Access Compliance Report

Public Rights-of-Way

(Curb Ramps)

Intersection ID: 21910	Main Street: CARMEL_RD	Cross Street: COLONY_RD	Location: SW
ADA ID: E5249FCD2298	Ramp Type: ParaDiag	Initial Pass/Fail: Fail	Overall Compliance: No
		Severity Score: 12.5

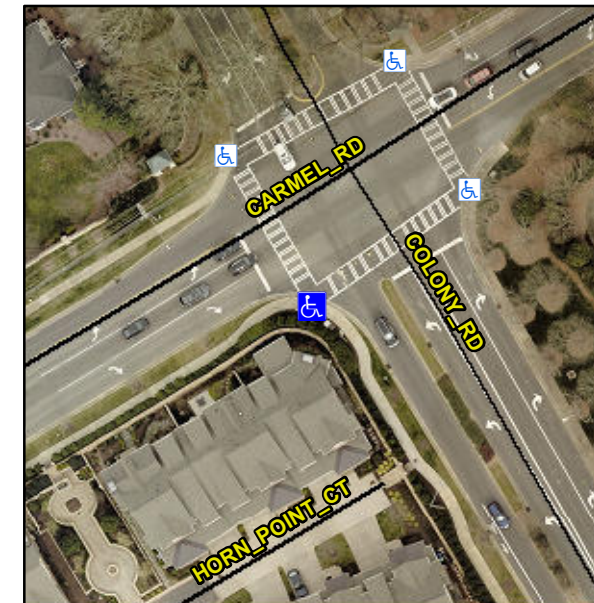
RT RP < 5%

R304.3.2

Compliance	Description	Data	Compliance	Description	Data
N/A	Ramp Length LT (in)	68.0	N/A	Ramp Length RT (in)	61.0
Yes	Ramp Width LT (in)	72.0	Yes	Ramp Width RT (in)	72.0
No	Ramp Slope LT (%)	11.8	Yes	Ramp Slope RT (%)	3.0
Yes	Ramp XSlope LT (%)	1.7	Yes	Ramp XSlope RT (%)	1.6
N/A	Landing Length (in)	N/A	N/A	DWS Provided?	N/A
N/A	Landing Width (in)	N/A	N/A	DWS Contrast?	N/A
N/A	Landing Slope (%)	N/A	N/A	DWS Length (in)	N/A
N/A	Landing X Slope (%)	N/A	N/A	DWS Full Width?	N/A
N/A	Landing Curb? (Y/N)	N/A	N/A	DWS Offset (in)	N/A
N/A	Shared Landing?	N/A			
N/A	Gutter Ponding?	N/A	N/A	Gutter Slope (%)	N/A
N/A	Gutter Lip Ht (in)	N/A	N/A	Gutter X Slope (%)	N/A
N/A	Painted X Walk1?	Yes	N/A	Painted X Walk2?	Yes
	X Walk 1 Direction	To NE		X Walk 2 Direction	To NW
N/A	X Walk 1 Width (in)	111.0	N/A	X Walk 2 Width (in)	109.0
	X Walk 1 Slope (%)	3.9		X Walk 2 Slope (%)	0.4
	X Walk 1 X Slope (%)	0.9		X Walk 2 X Slope (%)	5.8

Remove & Replace Curb Ramp With Two New Directional Ramps or Equivalent.
